PROJECT PHASE:
BID PACKAGE 03

SHEET NUMBER:
S1.02

BASEMENT
FOUNDATION PLAN -
SECTOR 2

College of Osteopathic Medicine
AT THE CHEROKEE NATION
TAHEQUAH, OKLAHOMA

01 FLOOR PLAN LEVEL 02 SECTOR 01
1/8" = 1'-0"

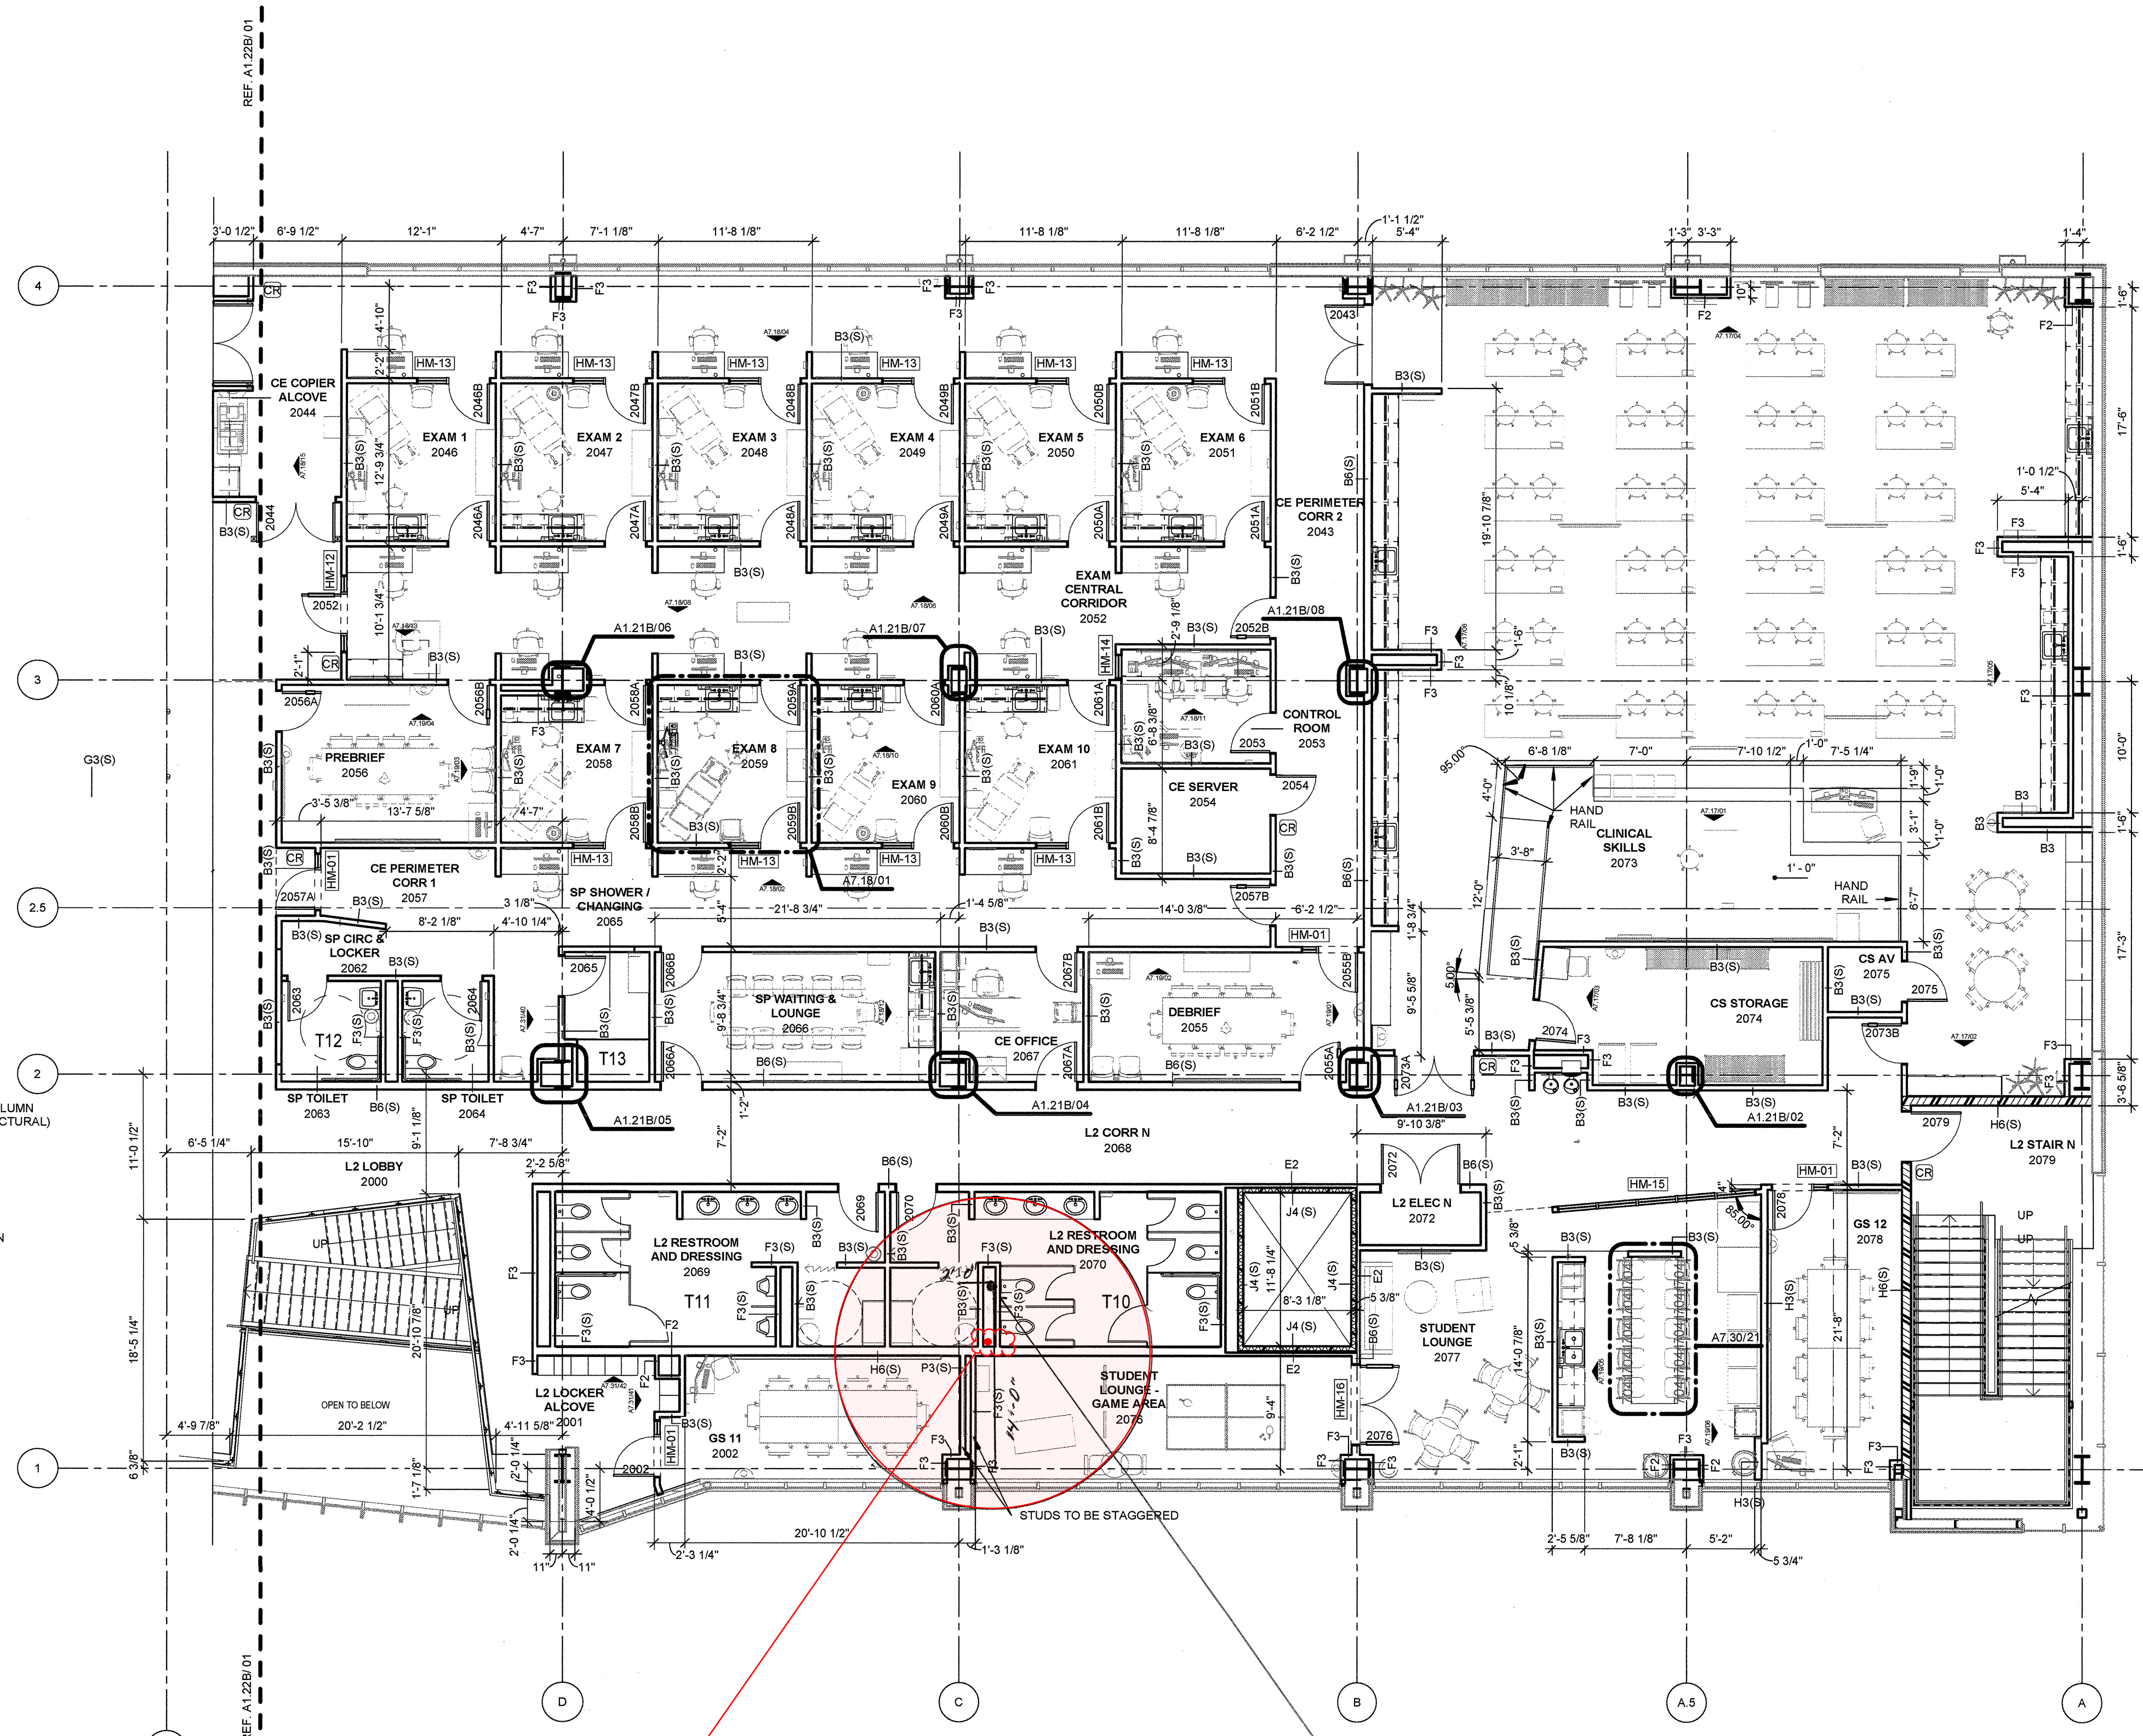
MOVE PIPE EAST PER
REQUEST FROM MEP
TO AVOID CONFLICT
WITH MEP ABOVE

Continuation Through 2nd Level above
Slab on grade.

01 FLOOR PLAN LEVEL 03 SECTOR 01
1/8" = 1'-0"

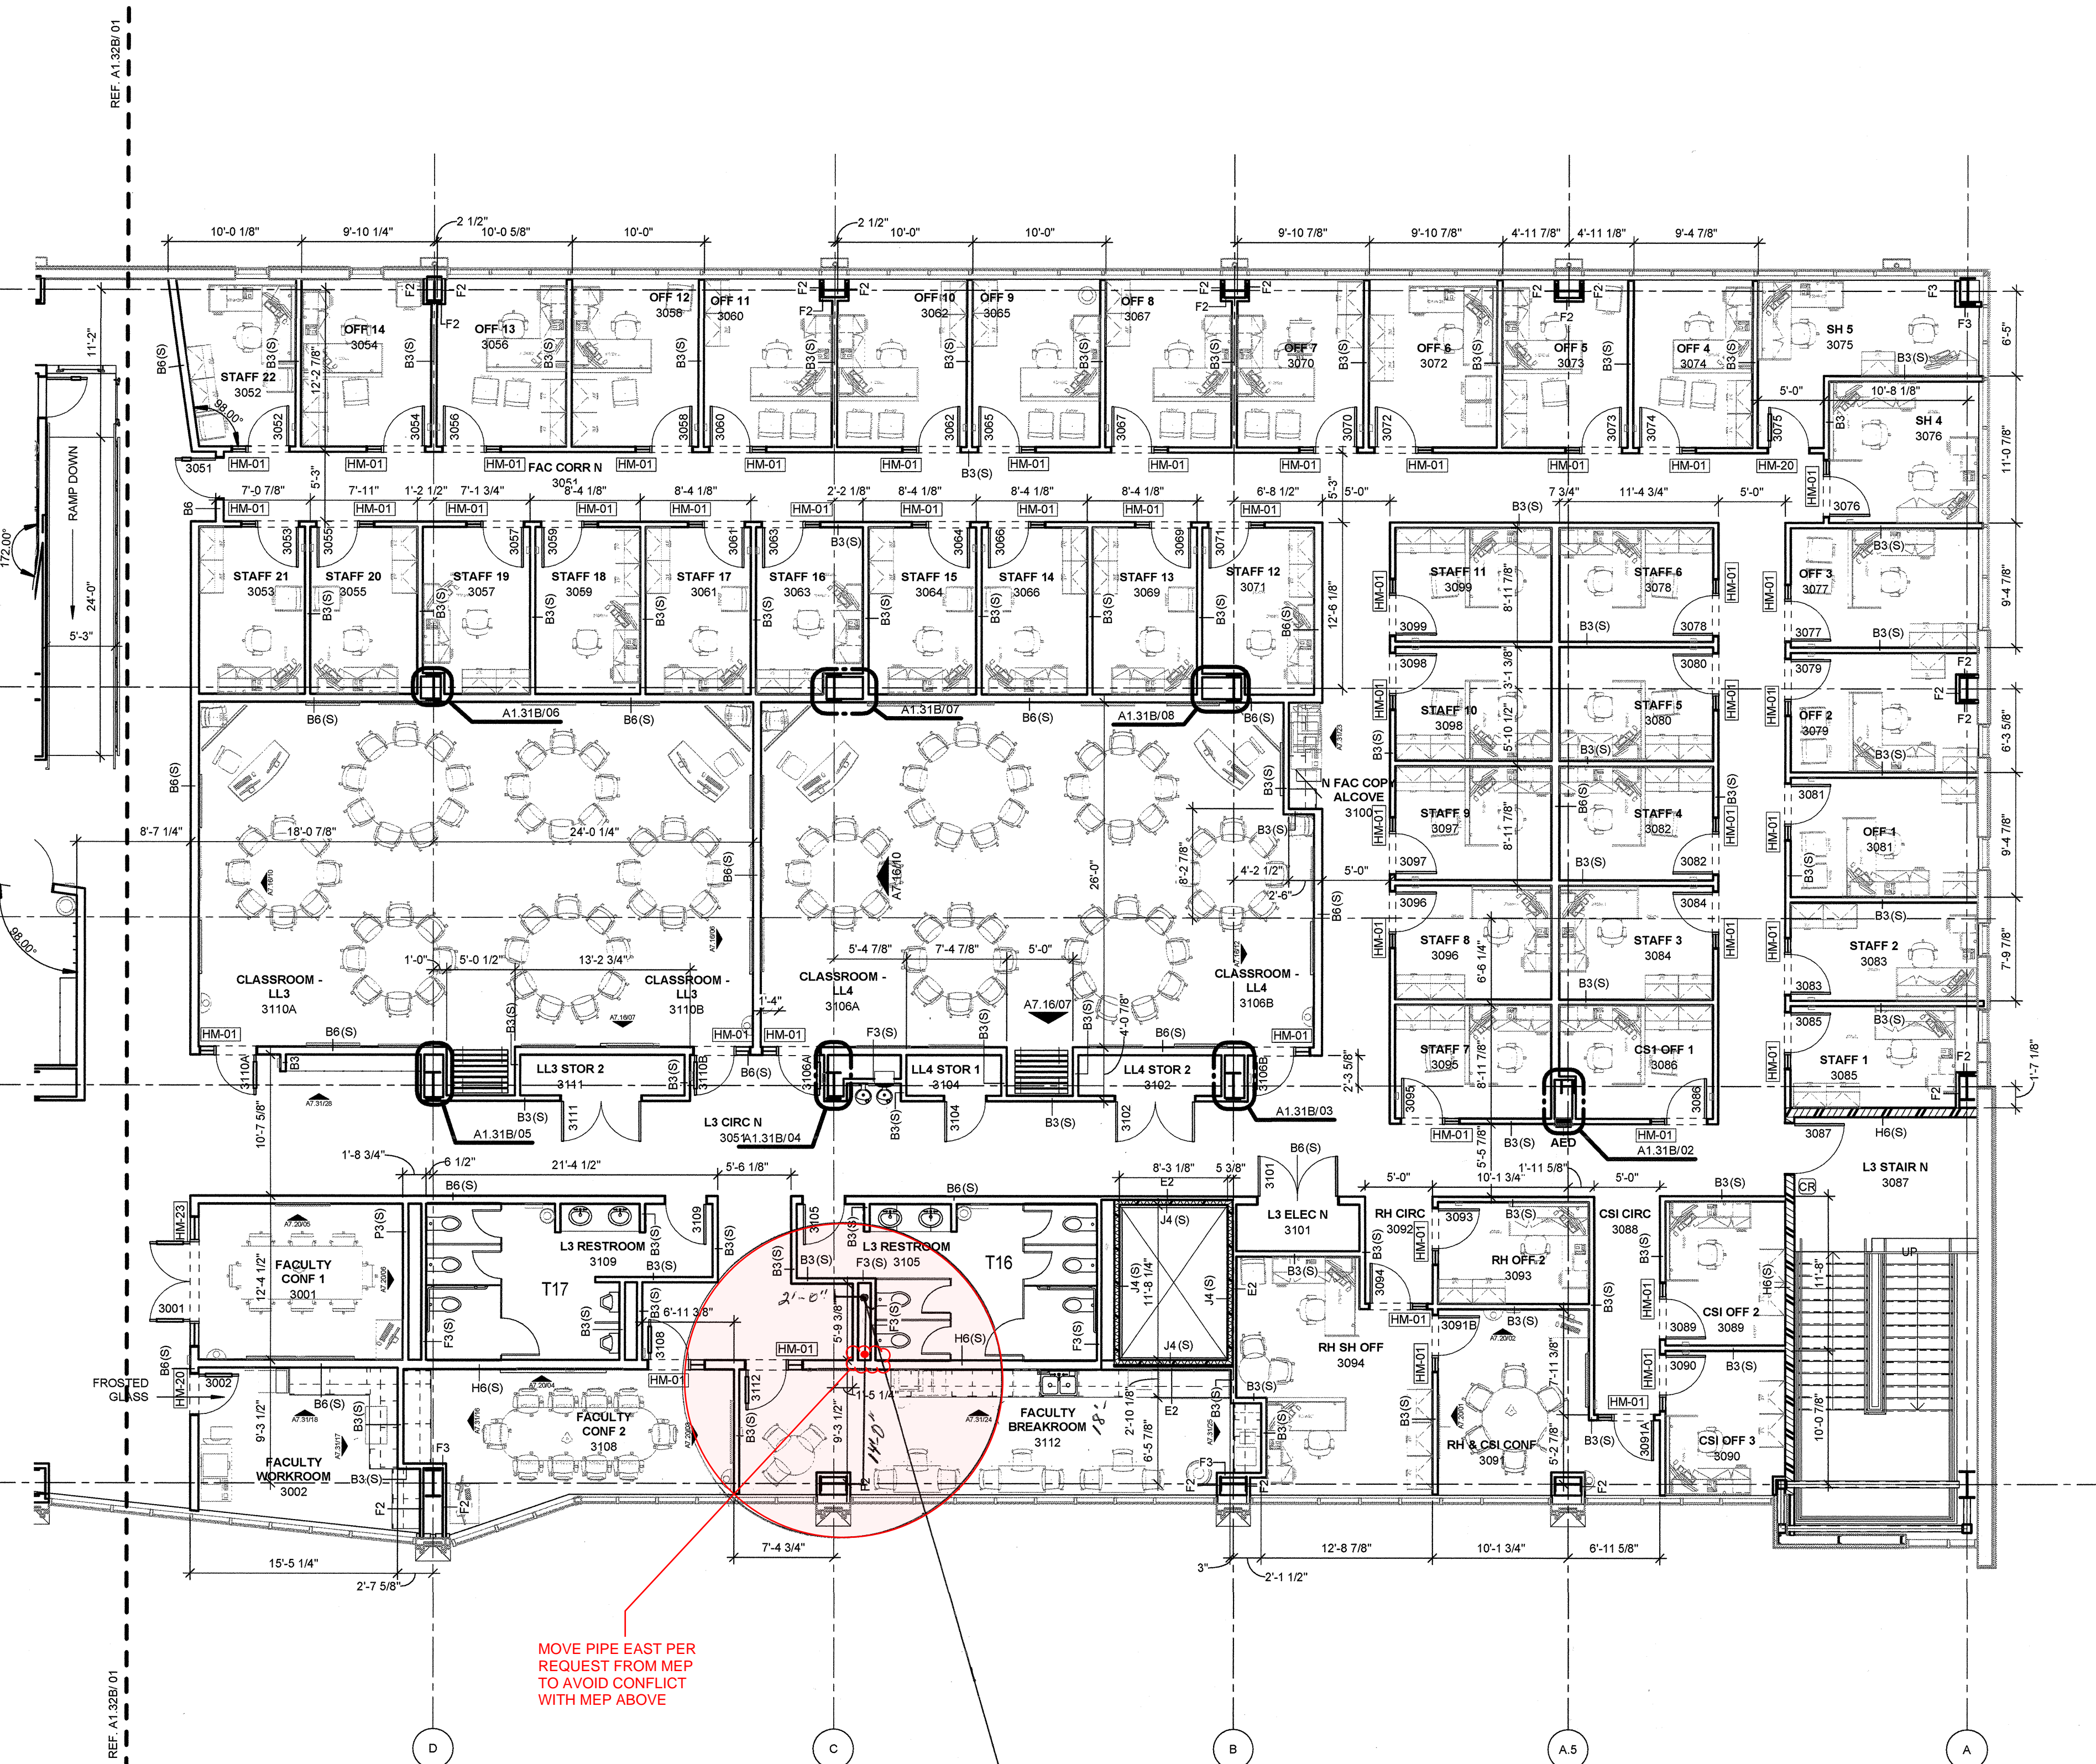
Continuation Through 3rd level above
Slab on Grade.

01 OVERALL ROOF PLAN
3/32" = 1'-0"

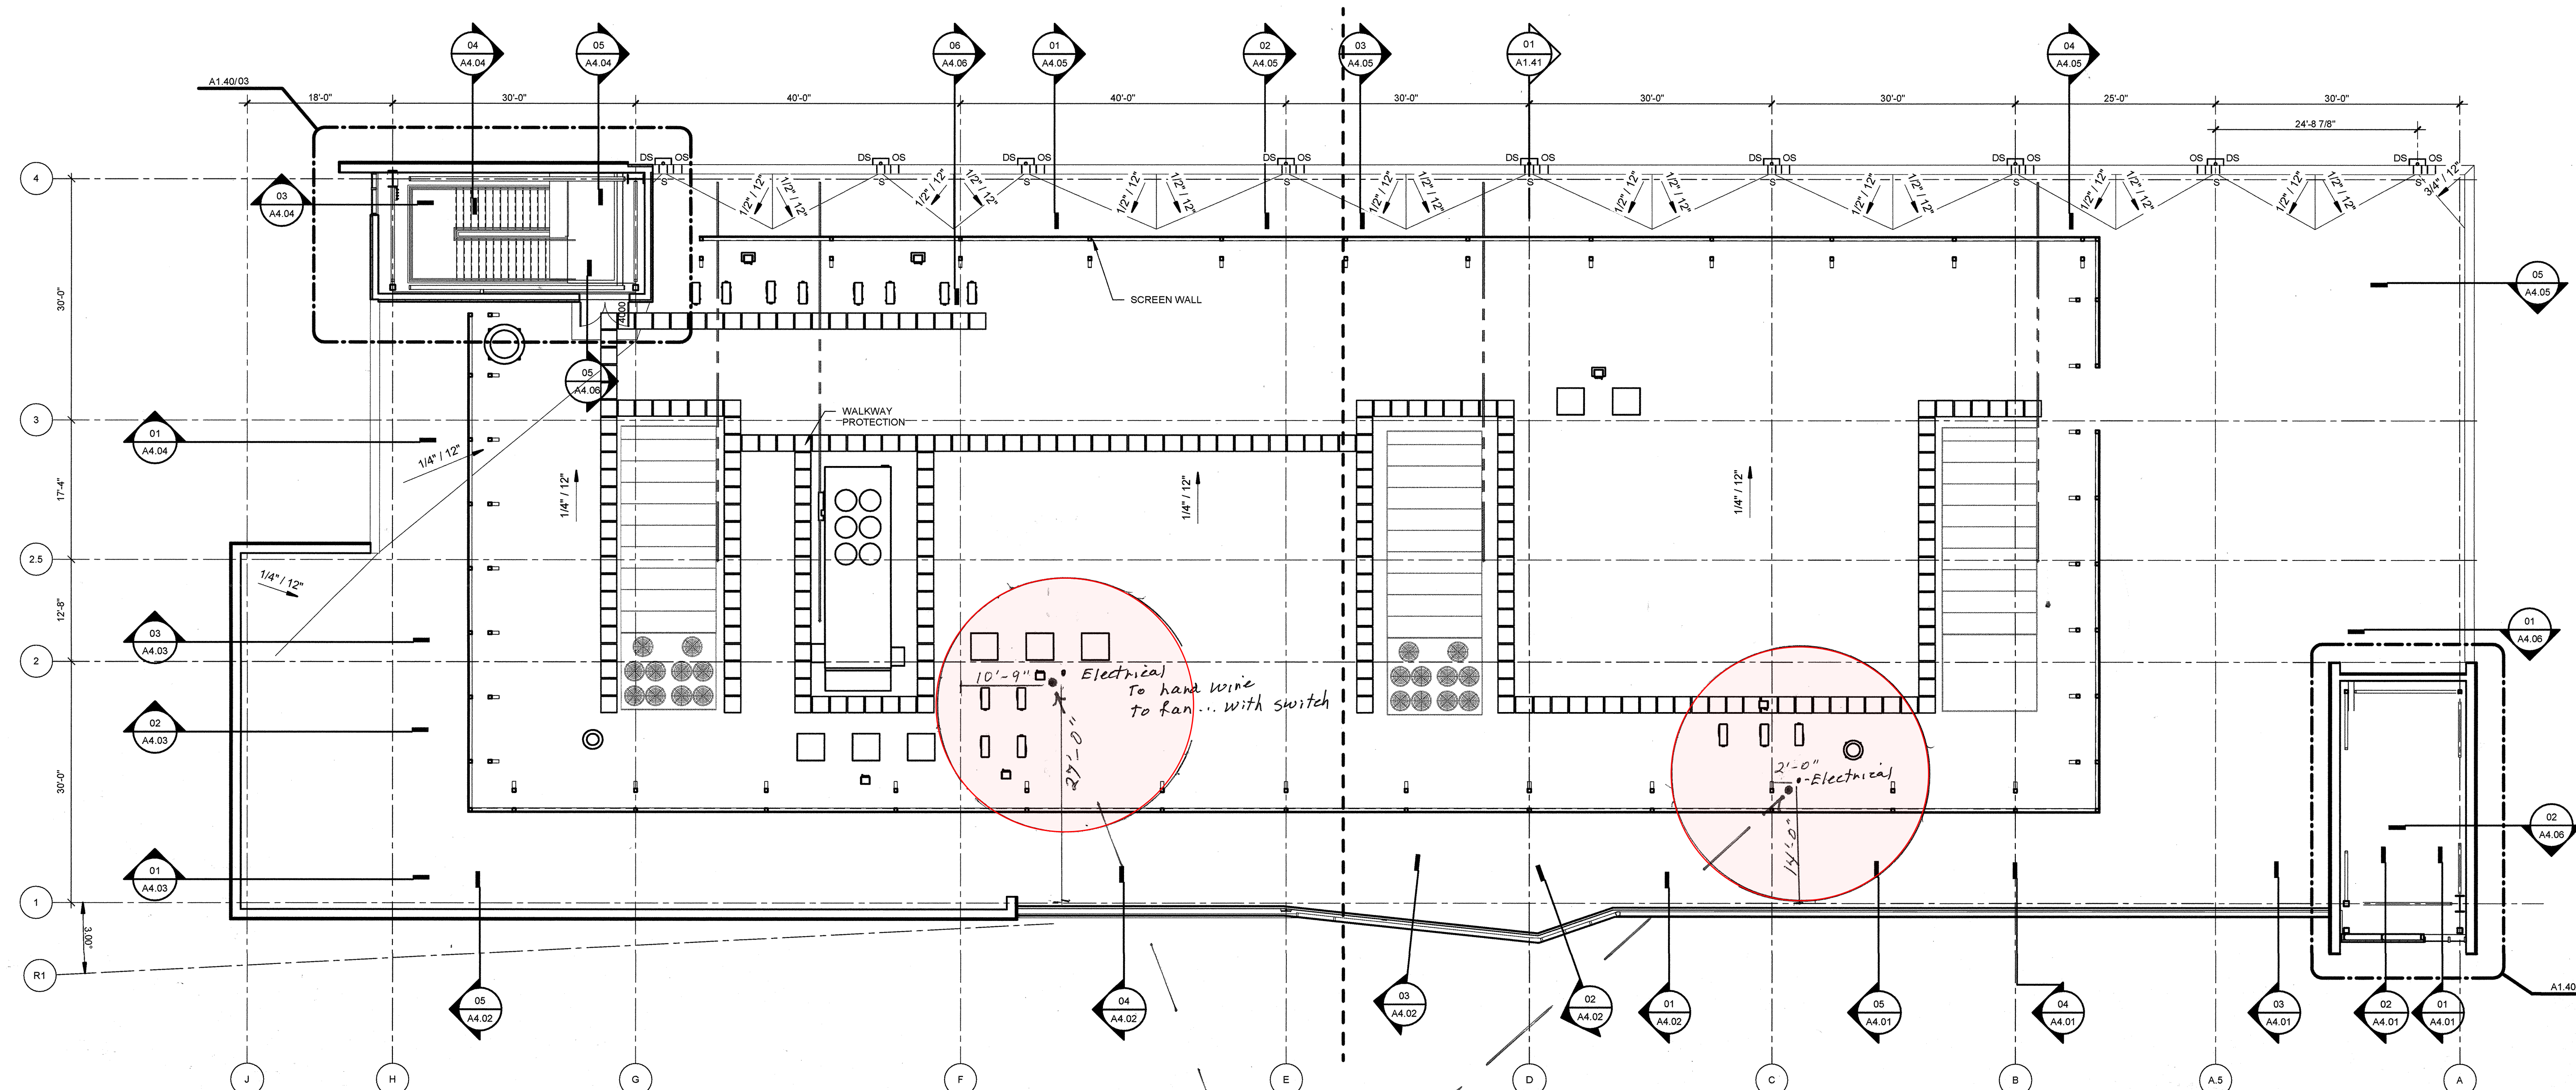
- (2) Roof Penetrations: Directly above vertical runs from slabs
- (2) RadonAway RP265 fans:
6" throat will require rubber couplings
from 3" to 4"; then 4" to 6" going in, then
6" to 4" going out; then a 4" 90° to
blow air to side; then a Varmint-gend
screen on end.
Stub out at approx 18"
